**Re: City of Manzanita (PWS ID #00505) Highlands Subdivision – Phase 5 (PH V)
Conditional Approval - PR #114-2022**

City of Manzanita (PWS #00505) Highlands Drive (Pacific Dunes #8) Subdivision – Ph V

Conditional Approval (PR#114-2022)

Phase V (PR #114-2022)

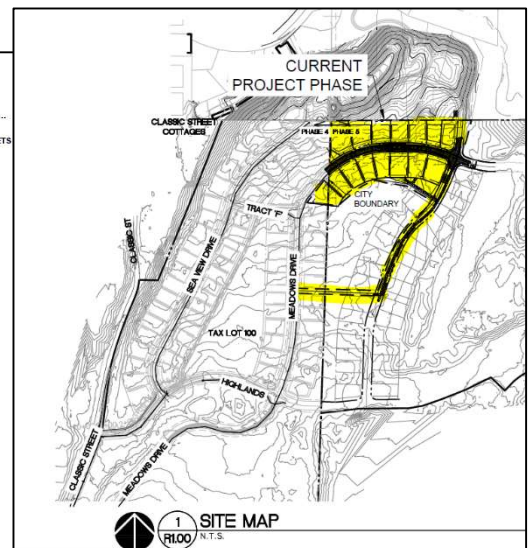
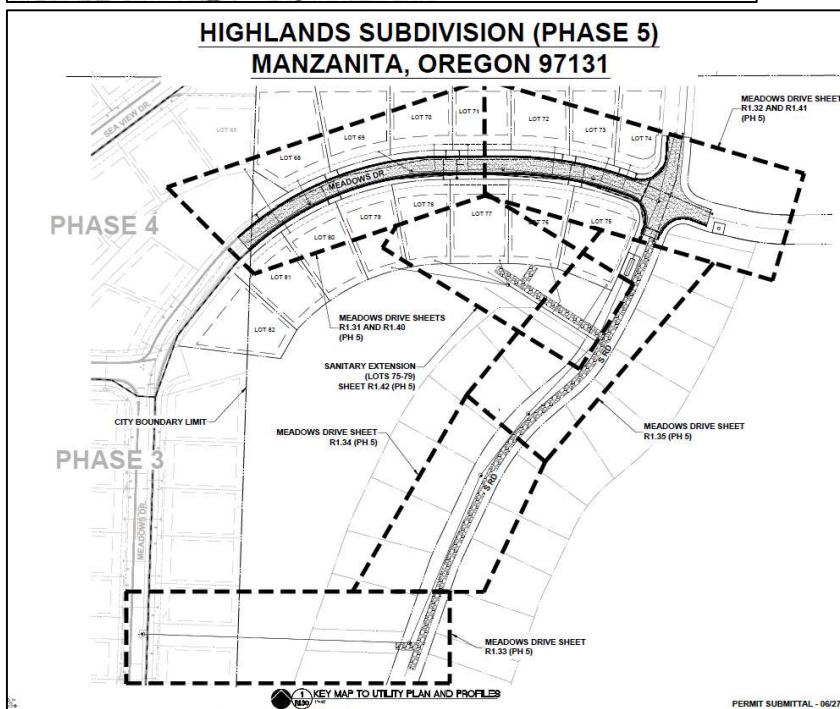
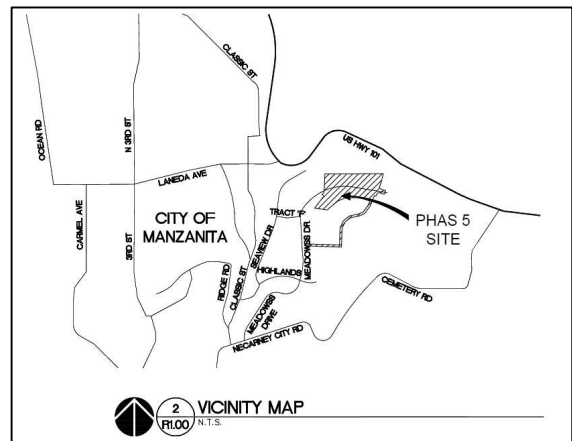
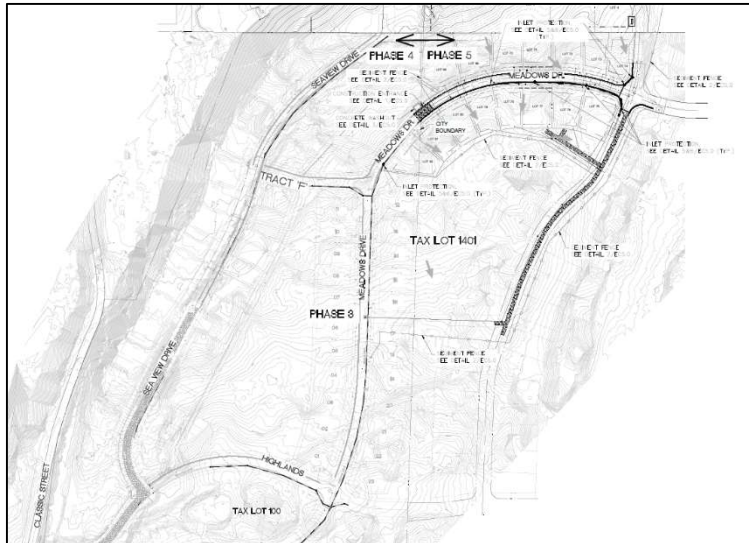
1. An AWG #18 (minimum) tracer wire is installed per [OAR 333-061-0050\(8\)\(k\)](#):
Nonconductive water pipe (plastic or other material) that is not encased in conductive pipe or casing must have an electrically conductive wire or other approved conductor for locating the pipe when the pipeline is underground. The wire shall be No. 18 AWG (minimum) solid copper with blue colored insulation. Ends of wire shall be accessible in water meter boxes, valve boxes or casings, or outside the foundation of buildings where the pipeline enters the building. The distance between tracer lead access locations shall not be more than 1,000 feet. Joints or splices in wire shall be waterproof.
Tracer wire AWG was not specified in the trench detail on sheet R5.11.
AWG #12 is specified in the water service detail on sheet R5.11.

4. Locations where waterlines cross sanitary sewer lines meet requirements in [OAR 333-061-0050\(9\)](#). This is addressed on sheet R5.10 of the plans for Phase V.
